16452A-02

Information Only Service Note

16452A Liquid Test Fixture

16452A Connector Part Number change

Figure 1 Dimension difference for both types of connectors

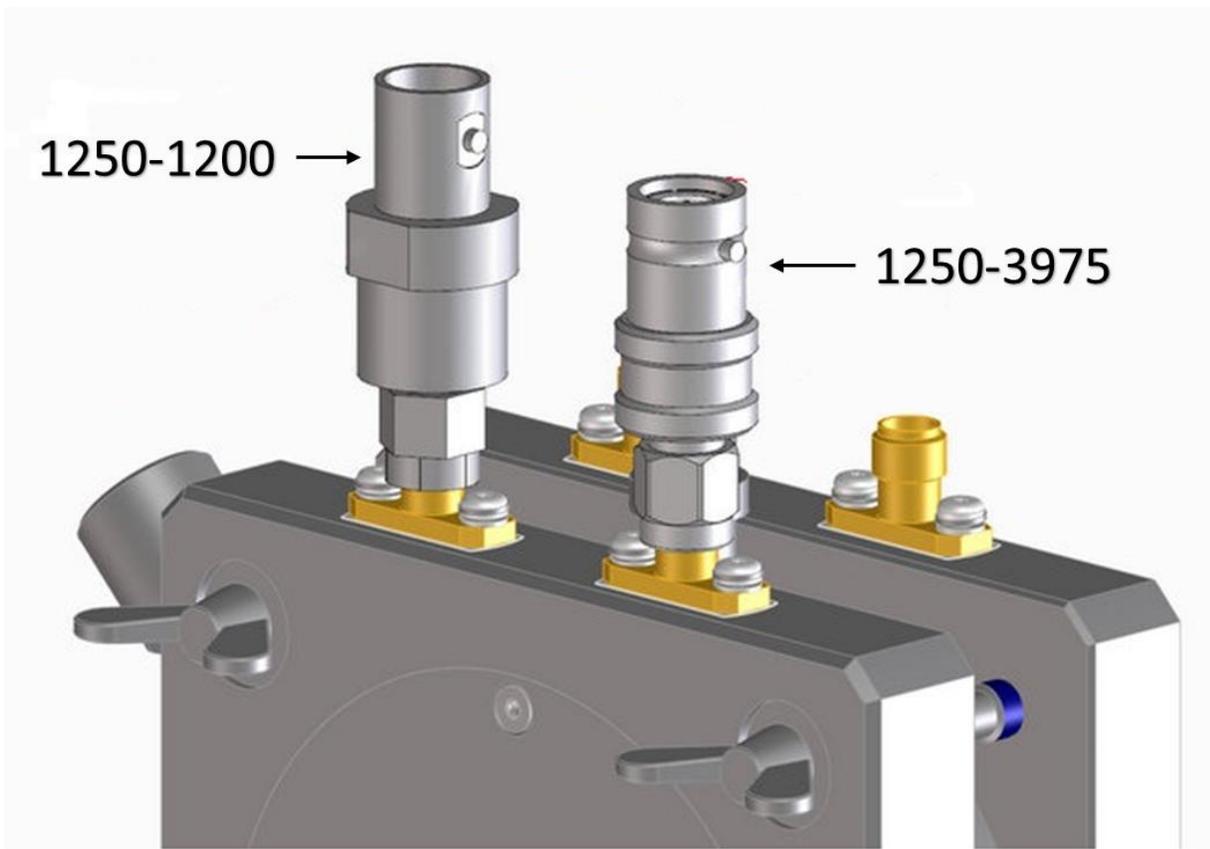
The connector for 16452A, 1250-1200 is discontinued and will be replaced by 1250-3975. Both connectors have physical dimension difference, but they are still compatible to other connectors and does not affect the performance for 16452A.

Existing Defective Part	Solution 1	Solution 2
1250-1200	If 1250-1200 is available, replace the defective part individually.	Replace all 4 of the connects with 1250-3975 even if only one of the connectors is defective.
1250-3975	If 1250-3975 is available, replace the defective part individually.	-
